Access Compliance Report Public Rights-of-Way (RR Crossings)

Intersection ID: 5967	Main Street: N_TRYON_ST	Location: N/A
ADA ID: 287BFC5DC4FE	Overall Compliance: No	Severity Score: 0.0
Codes/Mitigation Info/Possible Solution		Field Measurements/Component Compliance

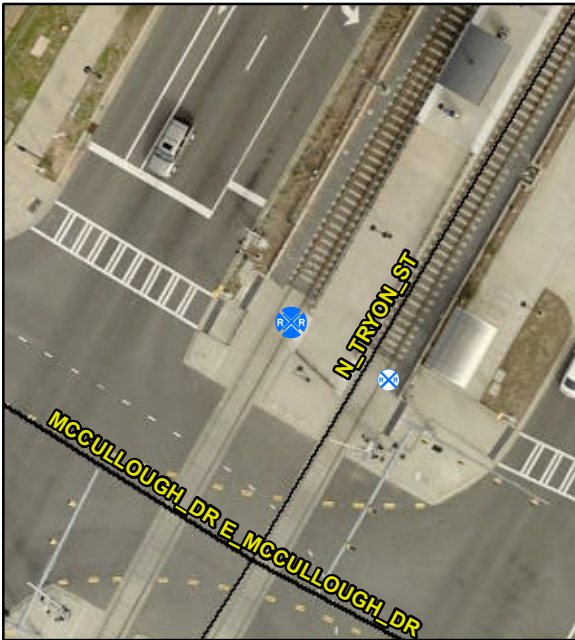
Remove & Replace Detectable Warning System. Provide Pedestrian Gate. Remove & Replace Walking Surface Adjacent to Rail.

Compliance	Description	Data
Yes	DWS Provided?	Yes
Yes	DWS Contrast?	Yes
No	DWS Width (in)	No
Yes	DWS Length (in)	24.0
Yes	DWS Offset (in)	115.0
No	Pedestrian Gate?	No
N/A	DWS Outside Gate?	No
N/A	Rail Type?	LightRail
No	Flangeway Gap (in)	3.0
Yes	Sidewalk Width (in)	137.0
